City of Portland, Maine - Building or Use Permit Application

Past Use: Vacant	Proposed Use: New 33 Unit PRUD / Application for units 11, 12, 13, 14, 15, 16, 17 and 18. Builds 4 and 5.
---------------------	--

Date: September 16, 2002
JN: 7516.1
To: Ed Cundy, P.E. Swift Engineering
Cc: Michael R. Charek, Architect
Dan L. Riley, P.E., Sebago Technics
From: Erik J. Wiberg, P.E. *EJW*
RE: Foundation Plan Review, Units 11 through 18, Radcliffe Glen Condominiums

Title
BASEMENT AND FIRST FLOOR
PLANS
UNITS 11 - 14

FIGURE 1

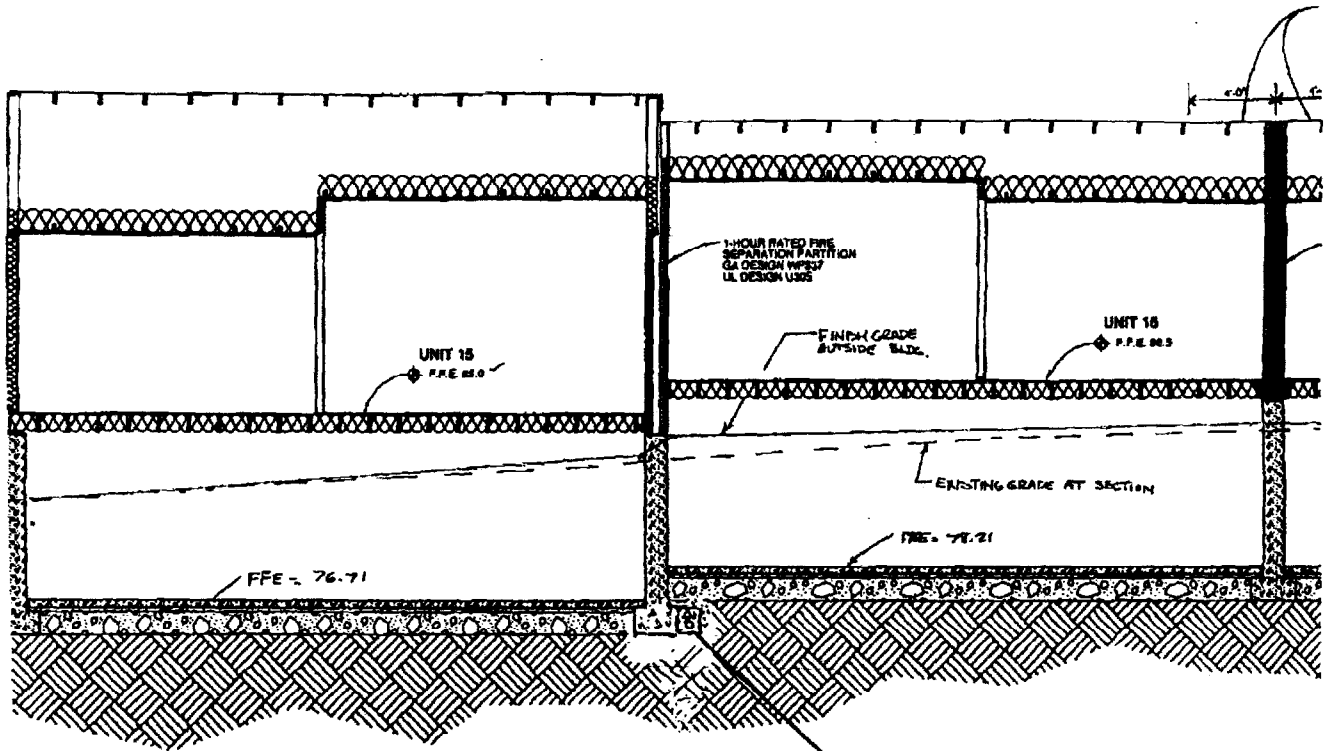
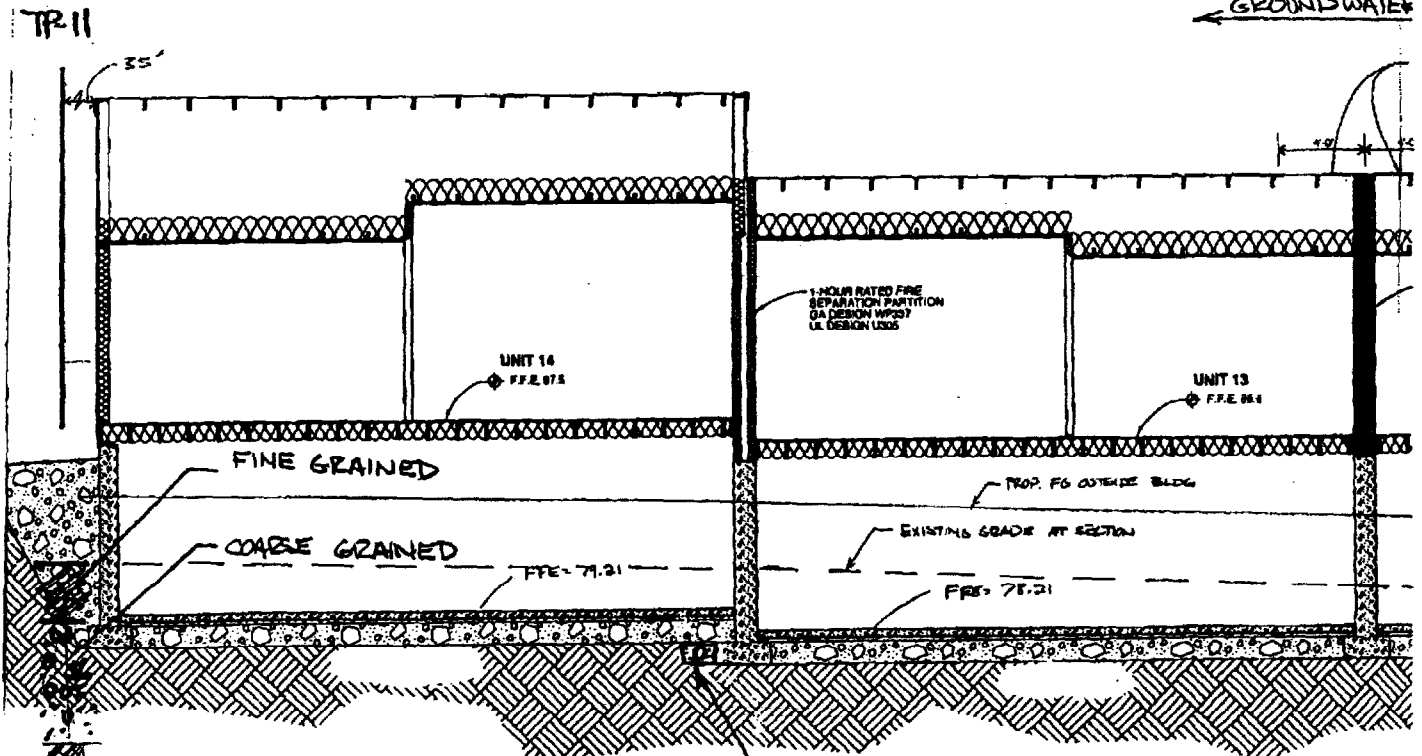
Based on subsurface conditions encountered at test pit TP-10, which was excavated within the footprint of the Units 11-14 building, and TP-12, which was excavated within the footprint of the Units 15-18 building, and the proposed finish floor elevations of the units, we recommend that foundation drains be placed at the bottom of footings where the basement slabs-on-grade step down in elevation in addition to the perimeter foundation drains recommended in our geotechnical report dated June 14, 2002. The proposed internal foundation drain locations are illustrated on Figure 1.

The internal wall footings at Units 11-14 could be located in coarse-grained glacial marine stratum overlying bedrock based on the proposed elevations and profile illustrated on Section A304. At the time of the exploration, groundwater levels were below the projected bottom of footings. Depending on the prevailing hydrogeologic conditions, the bottom of the footings could be located in groundwater during wetter periods of the year. Internal foundation drains will provide drainage relief for migrating groundwater and prevent buildup of groundwater behind the internal footings.

FOOTING TO BE RAISED
 TO BELOW SLAB PER
 CODE

Title	FIRST FLOOR FRAMING PLANS BUILDINGS 4&5 UNITS 11-18
Scale:	As Shown
Date:	8/15/02
Revisions	ISSUED FOR PERMIT
Sheet	S2

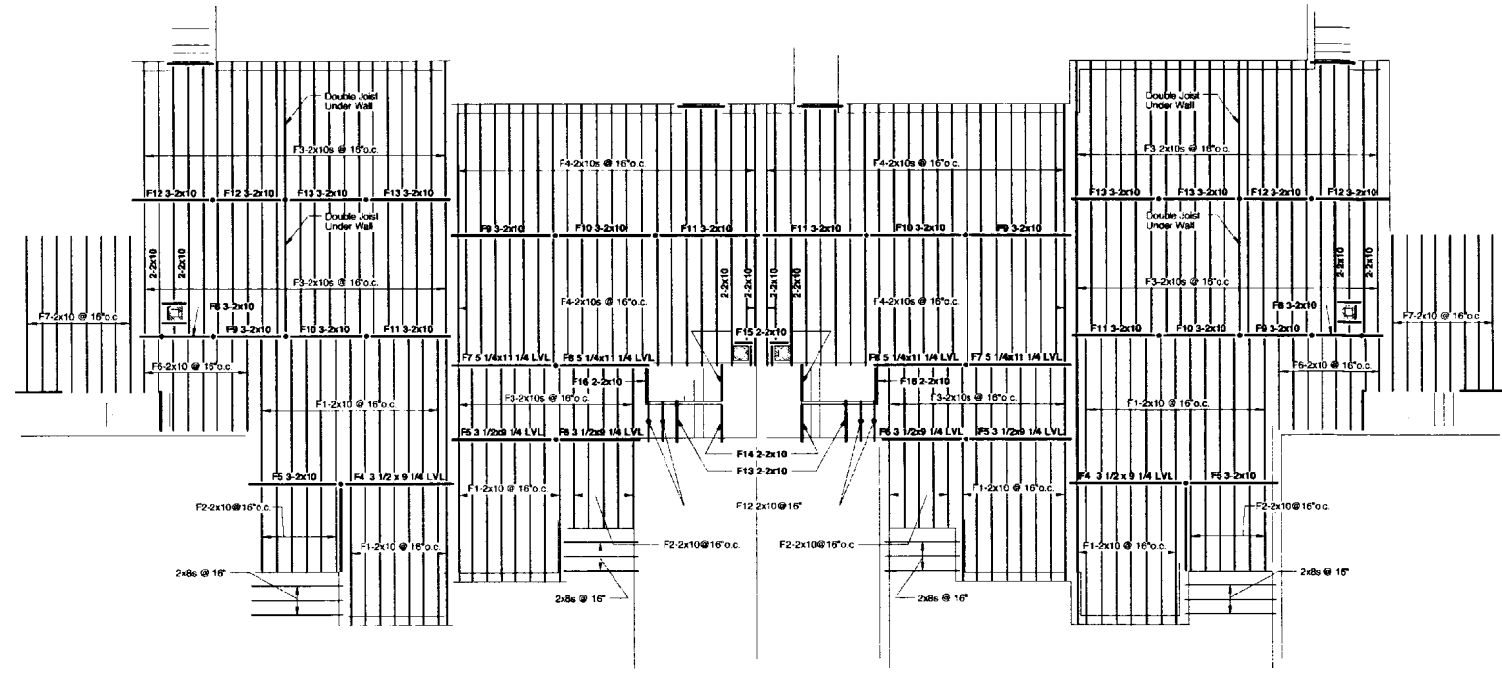
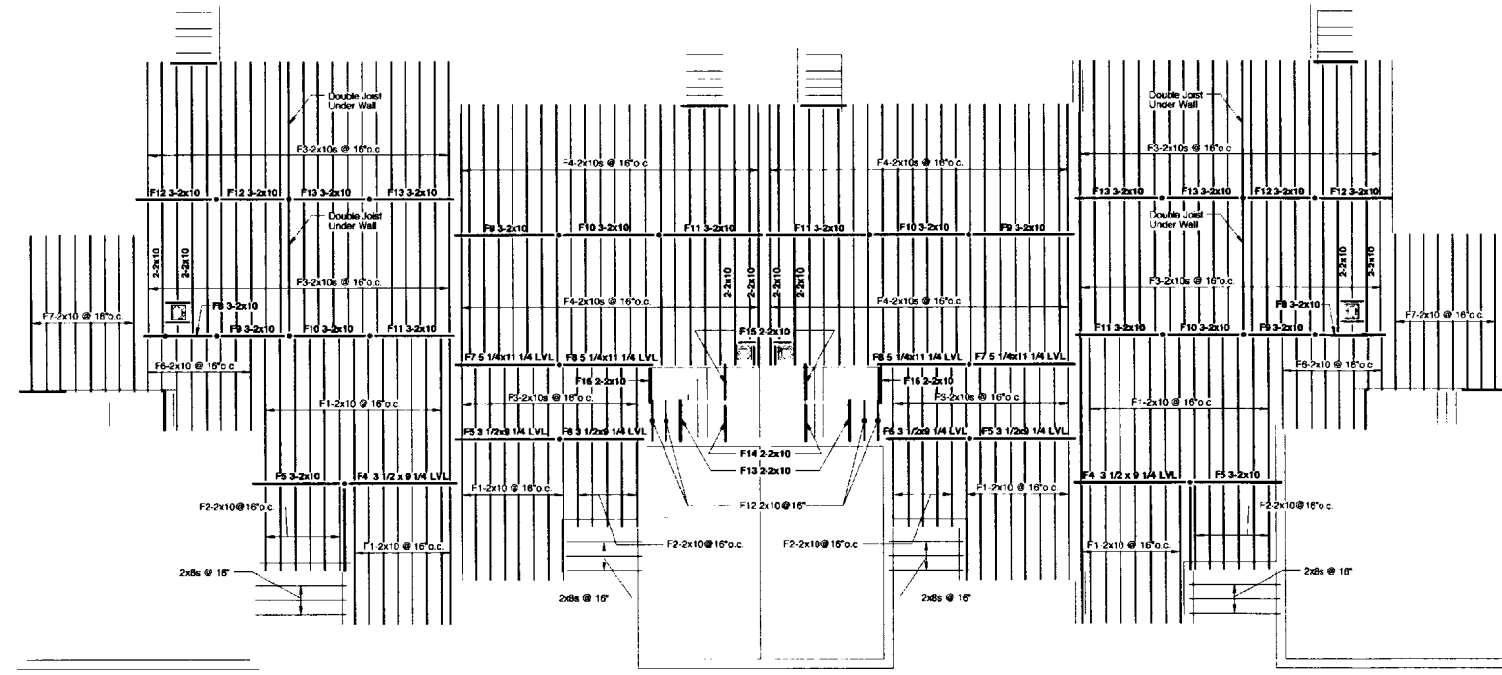
- Foundation anchorage details can be found on Sheet S2.
- Garages will be separated from the living units by one-hour rated partitions and floor-ceiling assemblies. The door from the unit into the garage is
